Amendments to the Drawings

REMARKS

Appl'n No.: 10/616,506
Title: ATTACHMENT MECHANISM FOR ...
Inventors: Shawn D. Stad, et al.
Annotated Sheet

FIG. 6 A

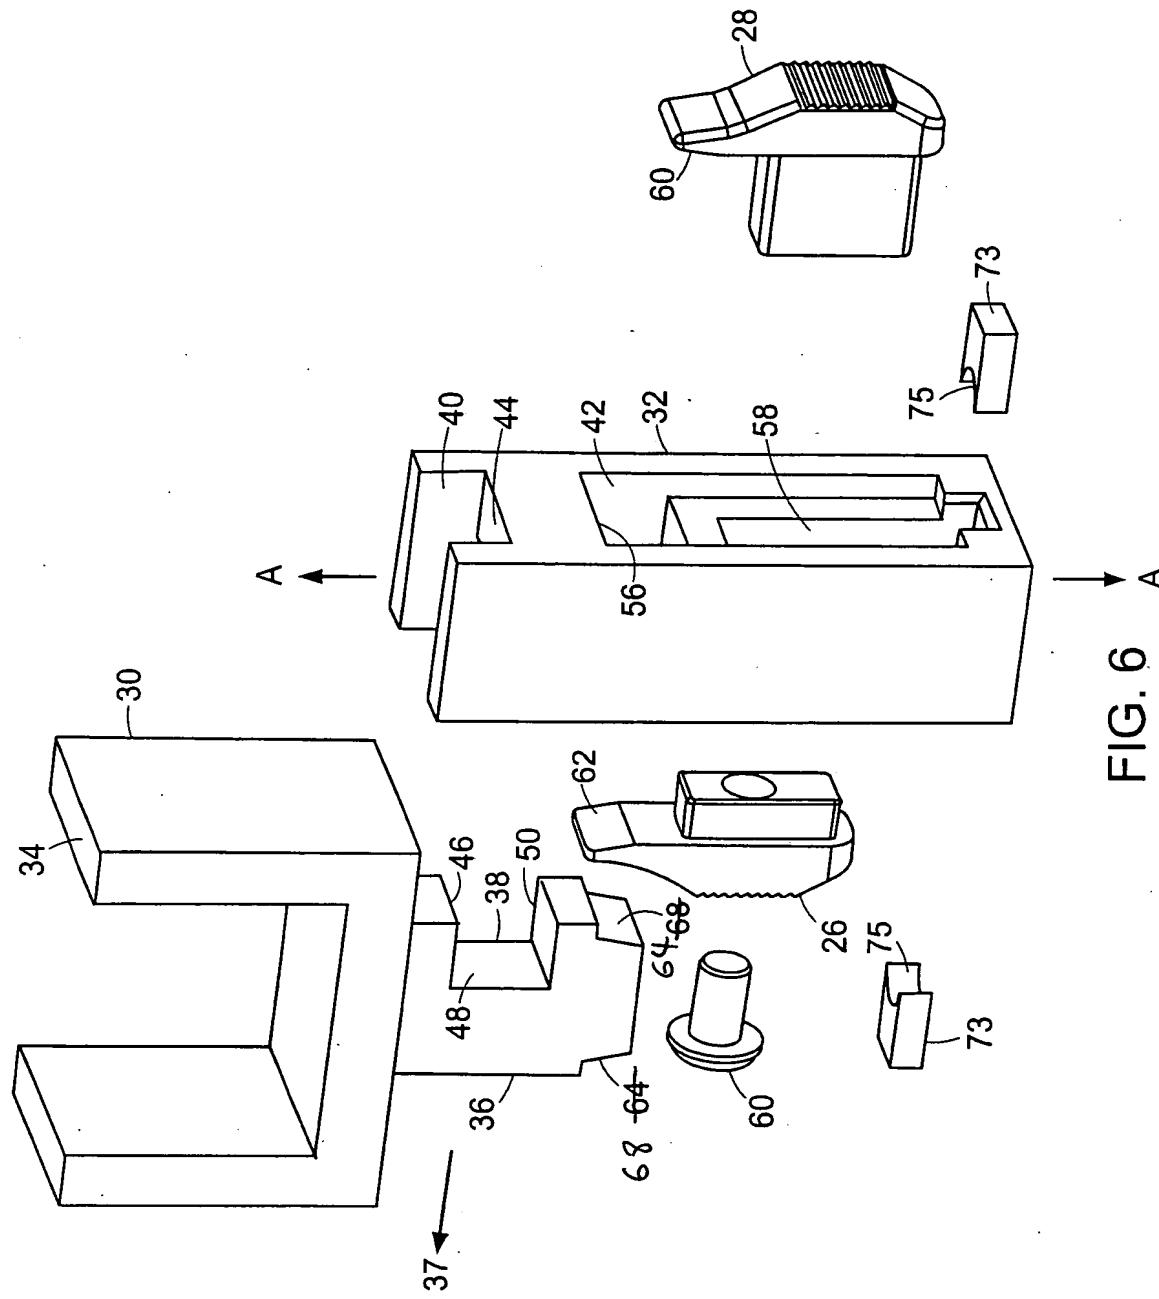
Comparing to Fig. 2, the surfaces 64 and 68 in Fig. 6 are erroneously identified. The surfaces 64 and 68 in Fig. 6 are now consistently identified as Fig. 2. In compliance with 37 C.F.R. § 1.83(a), Replacement sheet for Fig. 6 is submitted. Support for this amendment is found at, for example, page 22, lines 18 to 19.

The attached sheet of drawings include changes to Fig. 6 as detailed in the Remarks section below. Replacement sheet that includes Fig. 6 replacing prior filed Fig. 6. A Marked-up Fig. 6 also is attached.
